SOUTHEASTERN WISCONSIN REGIONAL PLANNING COMMISSION

MEMORANDUM

SUBJECT: SOUTHEAST WISCONSIN 2015 LIDAR (SEWI_5)

Appendix

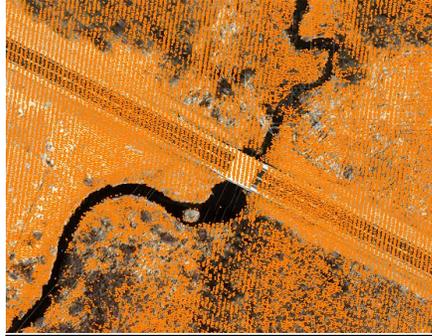
XY Location:
Northing: 488900
Easting: 2422800
Comment: Bridge classified using Classes 1 and 17 (Non-Ground and Overlap Non-Ground)...should be Class 14 (Bridge)

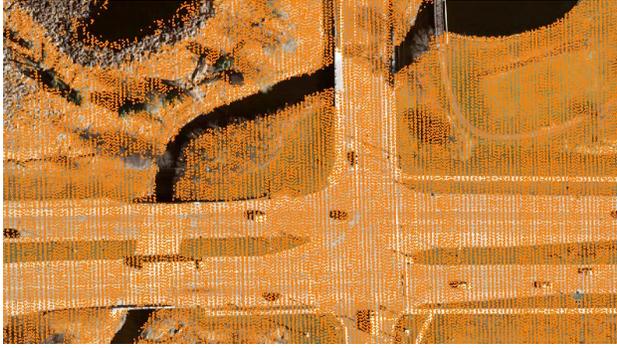
XY Location:
Northing: 477200
Easting: 2476400
Comment: Bridge classified using Class 1 (Non-Ground)...should be Class 14 (Bridge)

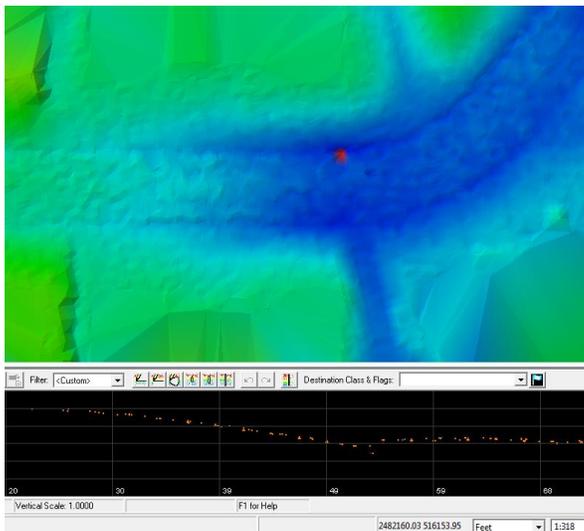
XY Location: Northing: 450600; Easting: 2497600
 Comment: Ground points left in surface causing improper contouring around structure.

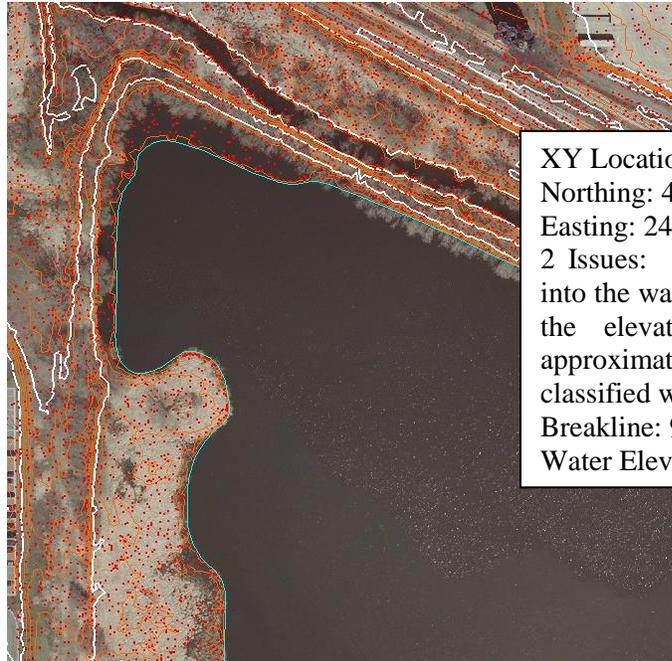
XY Location:
 Northing: 516154
 Easting: 2482167
 Comment: Ground points in storm sewer affecting the road elevation. Also model keypoint has a point in the storm sewer that would also affect the surface elevation

XY Location:
 Northing: 511425
 Easting: 2470591
 Comment: Single Model keypoint in water body.

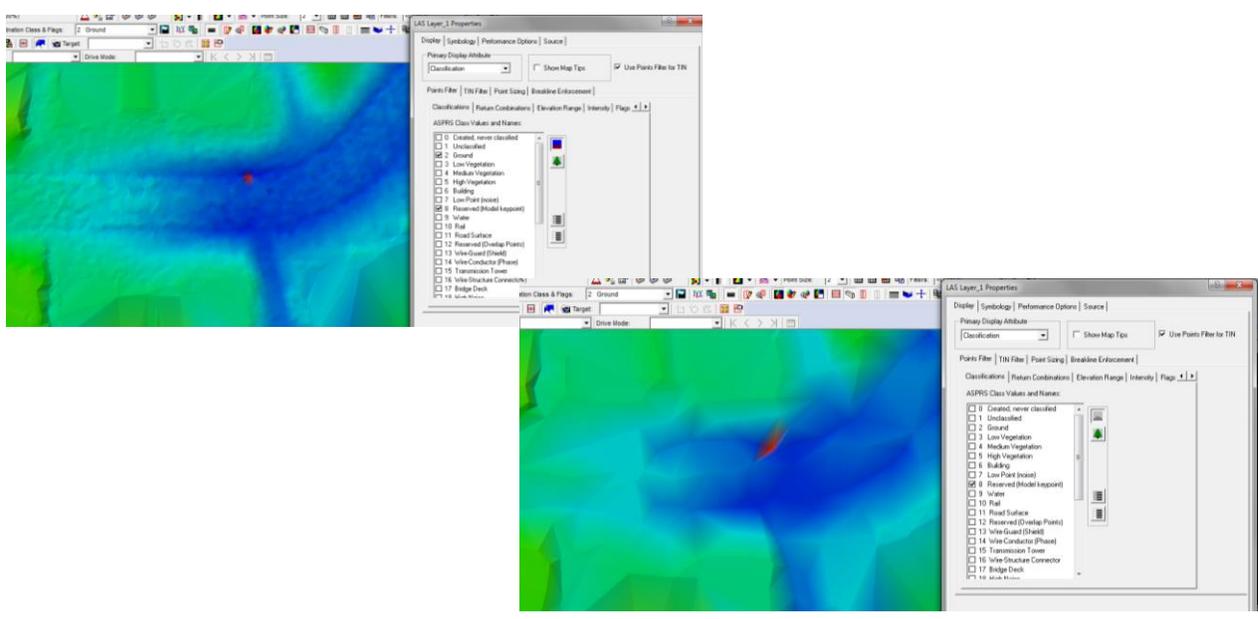
XY Location:
 Northing: 487400
 Easting: 2426200
 2 Issues: Hydro breakline encroaches into the water body significantly. Also, the elevation of the breakline is approximately 1.5 feet lower than the classified water points.
 Breakline: 956.000 feet
 Water Elev. approximately 957.5 feet

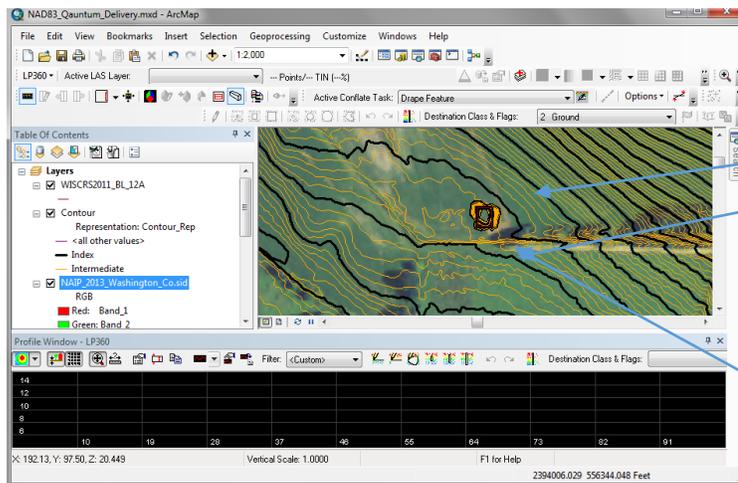
- Data provided in wrong format
- Data also provided on wrong datum
- Quick review comment – Design file had wrong working units assigned. See screen capture below for future reference but is no factor since the data format will change:

NAD83 Position:
X = 2394009ft; Y=556345ft

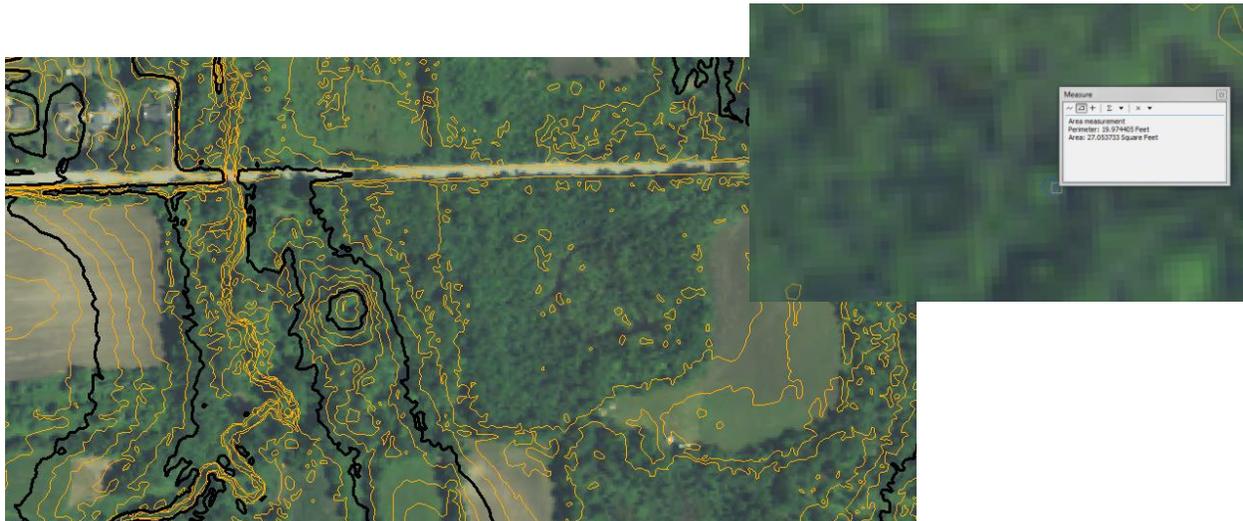
- A zero elevation breakline has been included affecting the contour generation which needs to be removed and new contours generated.

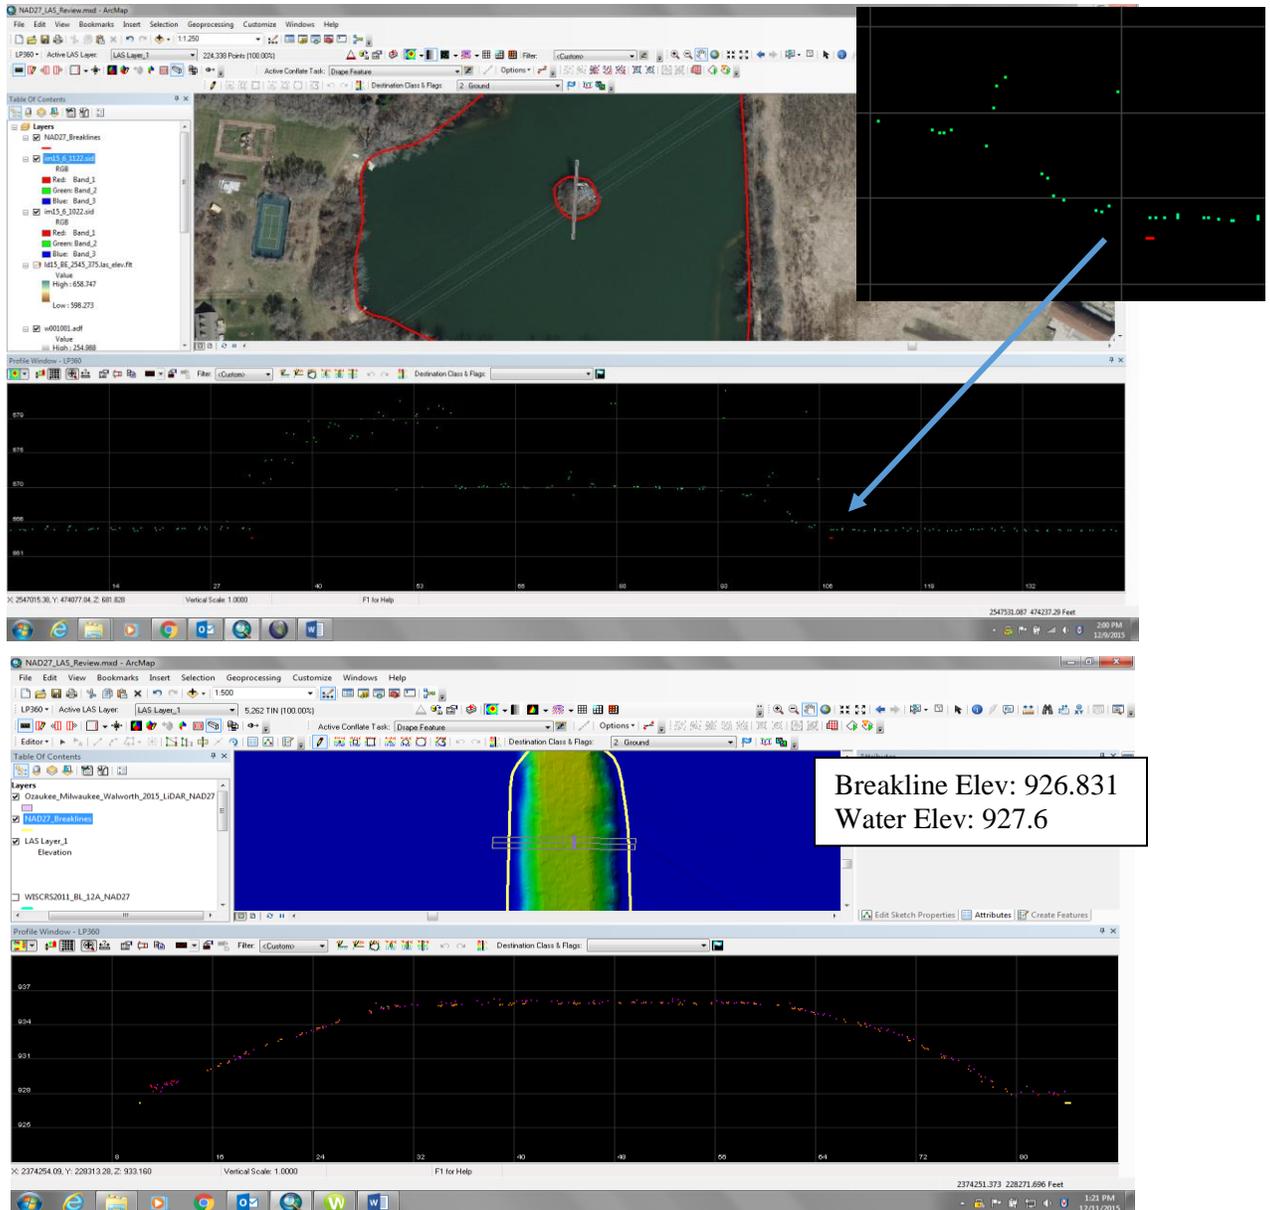
- Contouring filtering with removal of small contours are still evident throughout. Sample below show small contours of 27 ft² are evident. Agreed parameters of tops being 40ft² and depression that are 400ft² were to be filtered out. Regeneration of contours using provided parameters is necessary to remove analogous contours.

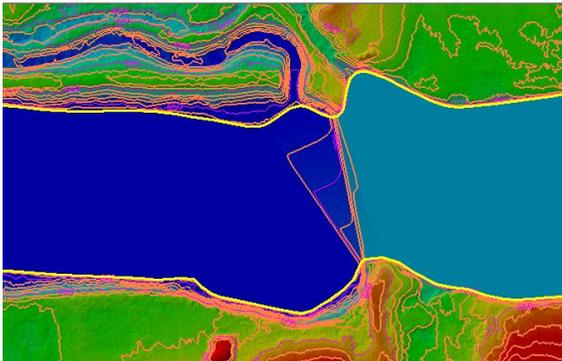
- Breaklines in the city of Port Washington have been terminated leaving the breakwater wall classified as water and/or non-ground. Continue breaklines along these features and re-class to ground. Below is area of concern with 2015 Ortho with breaklines in red and also LiDAR point data by elevation with breaklines in red of the same area.

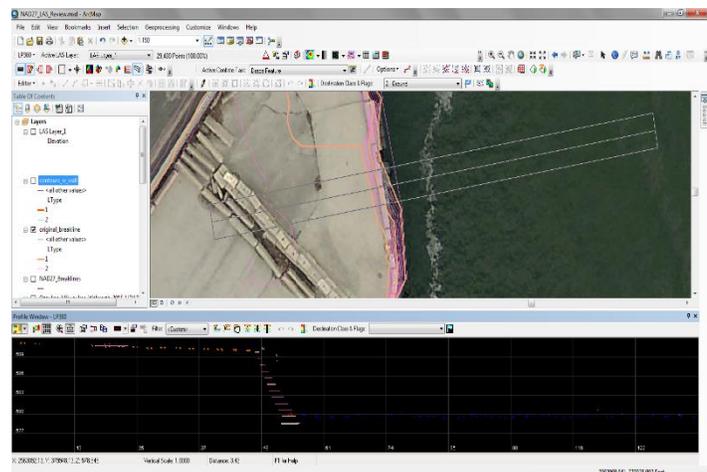
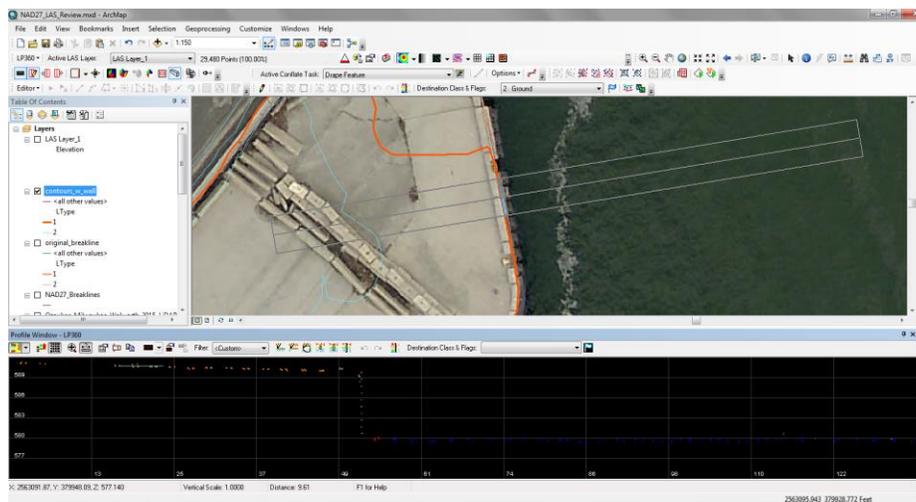
- Breaklines especially near walls have significant issues. The first issue is horizontal alignment accuracy. Most wall breaklines were collected well inside of the wall surface itself (i.e. breakline is placed in the water). The horizontal placement ranges anywhere from 3 – 10 feet off of apparent location which is cause numerous issues on the contour generation. Shown below is a location with both horizontal error and how the contouring looks when the breakline is enforced. The measured horizontal error on this sample below is 4.6 feet. The second major issue is the need to create a second breakline due to the significant vertical change and assurance of proper contouring around these features in meeting National Map Accuracy Standards. This second breakline allows proper enforcement and characterization of the topology around these specific wall features. The screen capture below shows what the contours look around this area. The Commission edited the existing line to locate it at the base of the wall itself and placing the breakline at the water surface of 580.0. The second breakline was created using LP360-retaining wall conflation tool.

- Below demonstrates how the wall contours would look with use of the second breakline and proper enforcement..

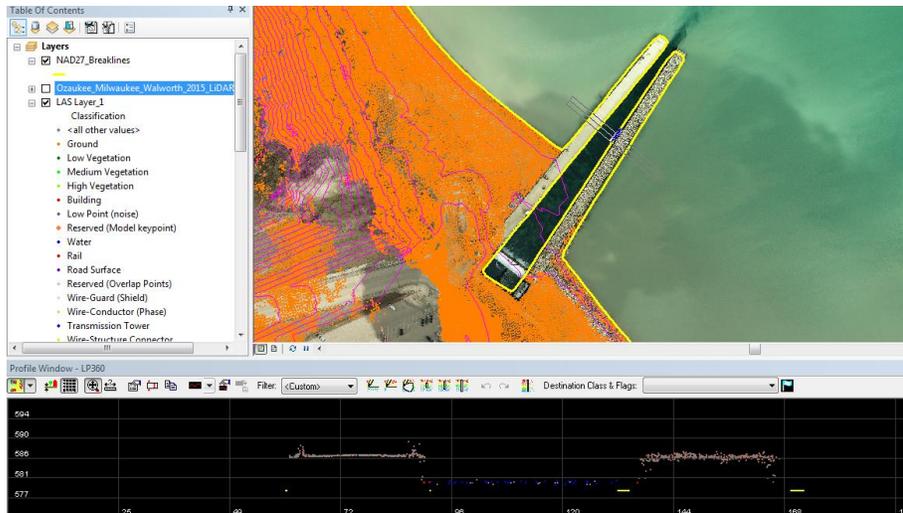
- Missing ground points and model keypoints. Need to put ground points back in surface supporting walls around collected breakline below.

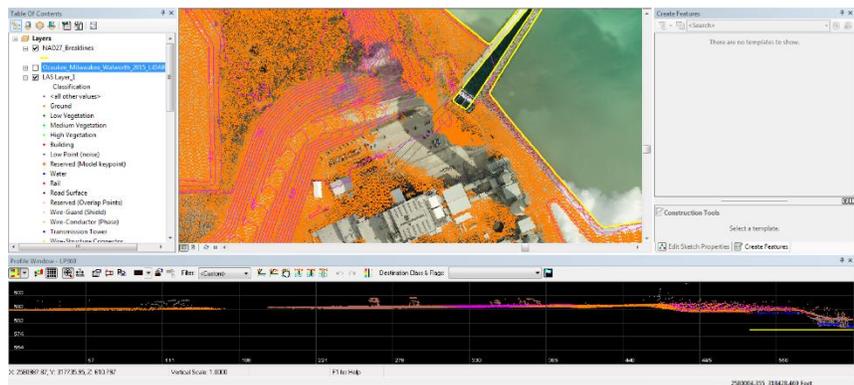
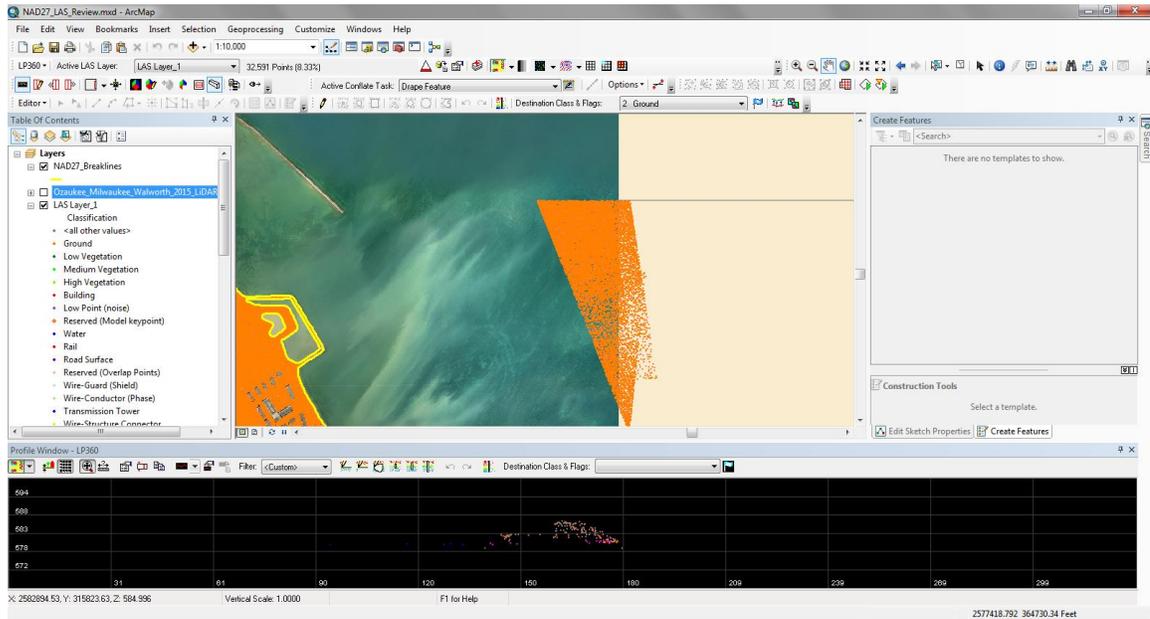
- Missing ground points around power plant. Smoke was causing a major ground obstruction on the primary flight line but the neighboring flight line(s) covered the ground well. Need to re-run ground around plant area to properly classify terrain. This mis-classification edit call was not in the shapefile but location was near the edit call location for ground points along the shoreline wall discussed above.

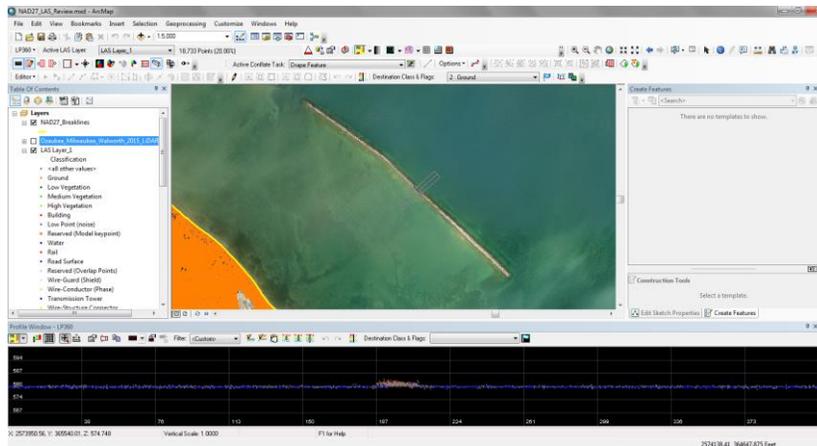
- Water points that were classed as ground. Need to re-classed points to water. These points are the tiles along Lake Michigan shoreline and are well out in the lake

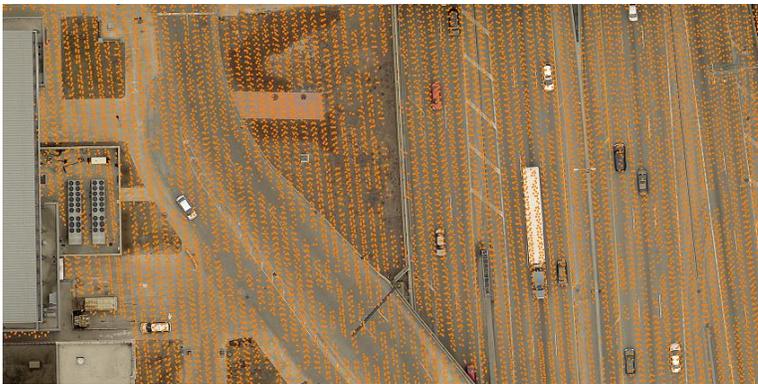
- Ground points missing causing the contouring to be affected.

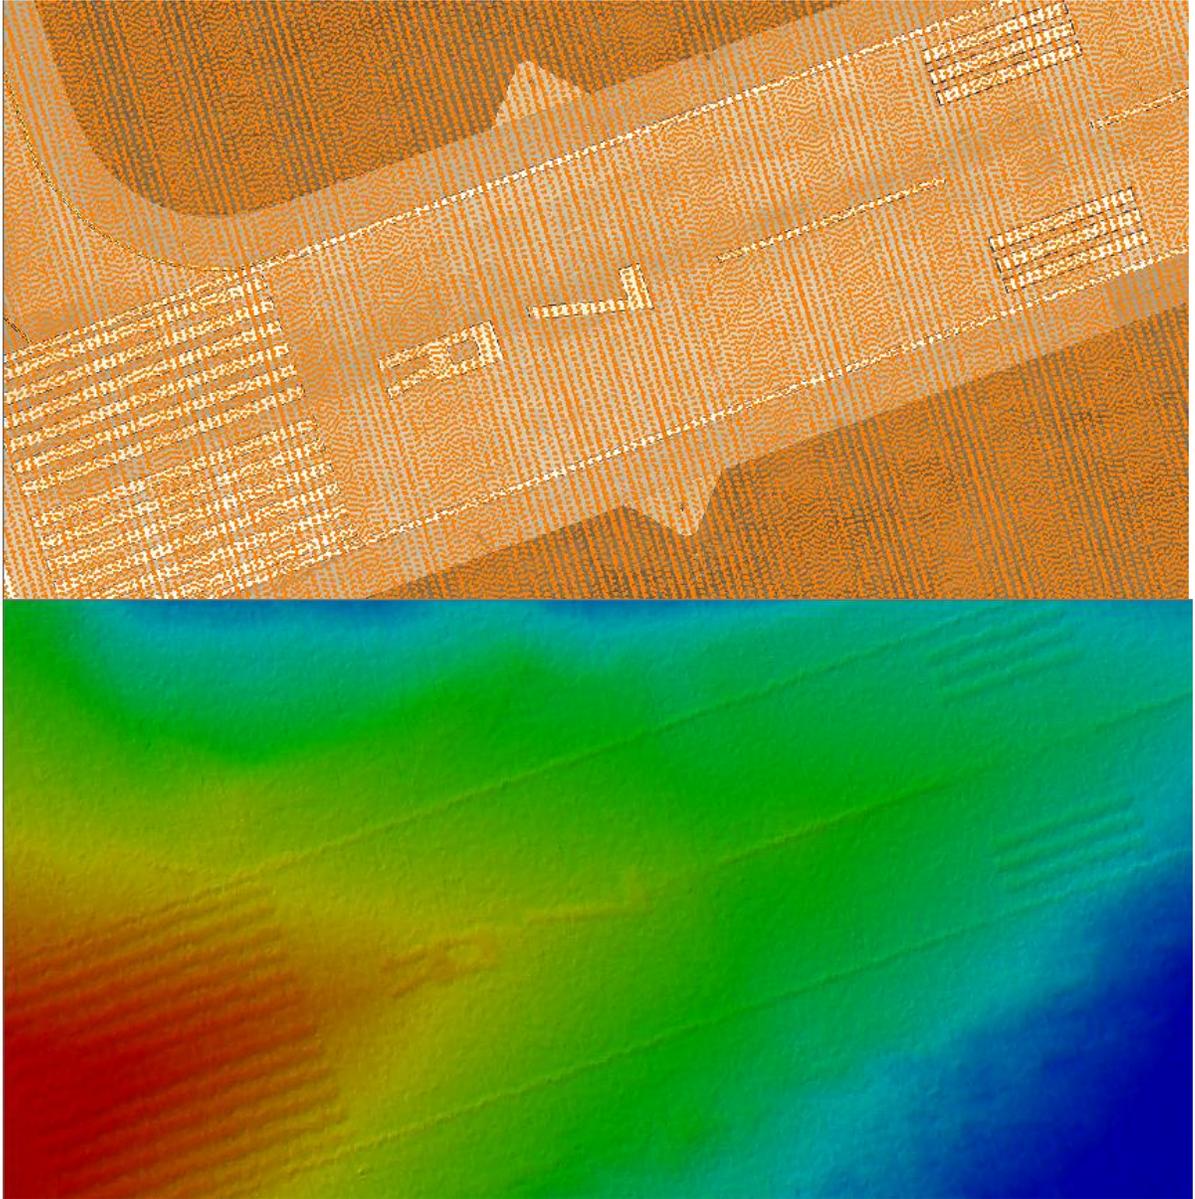
- Missing ground points along a transportation wall that affects contouring and DTM surface modeling. See below regarding a sample effect of the ground macro peeling back the ground points along a vertical feature.

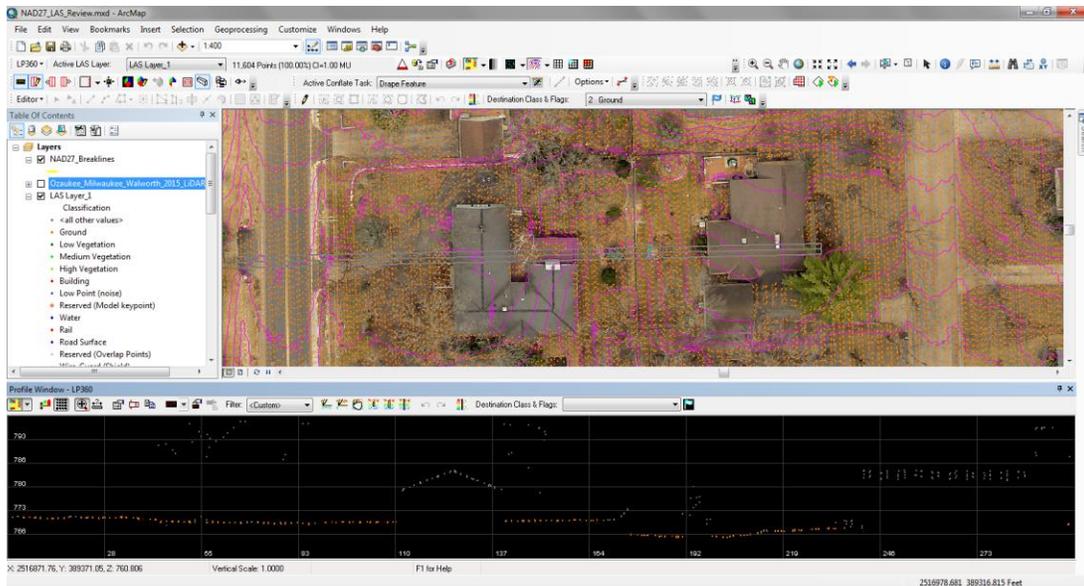
- Missing ground points in island breakline. Breakline capturing an island has been compiled but the ground points are missing. See below for an example.
